# Important Safety Notice

Martin Global Service

April 6, 2006

**RoboScan 918 Pro mounting bracket clamp plate (arrowed)**

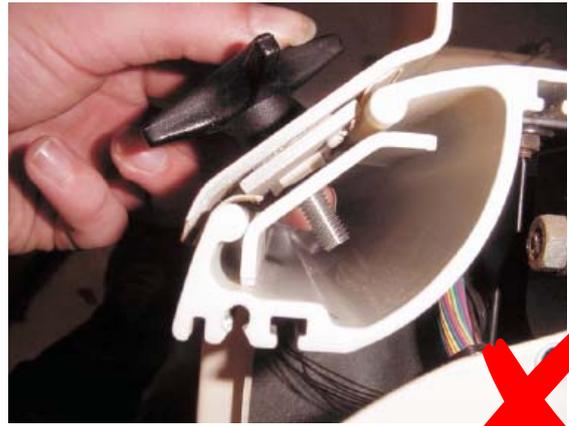
We have recently been made aware that it is possible to re-assemble a RoboScan Pro 918 fixture with the mounting bracket clamp plate (P/N 23803220) around the wrong way. Mounting the clamp plate incorrectly puts the mounting bracket in a dangerous condition because there is a risk that the fixture may fall out of the mounting bracket.

Please check all 918 fixtures to make sure that the clamp plate is assembled correctly, and pay extra attention to this plate when re-assembling 918s after service. The illustrations below and on the next page show where the plate is located and how to install it correctly.

**WRONG – Warning! Do NOT install the clamp plate this way around**

**RIGHT – Install the clamp plate this way around**
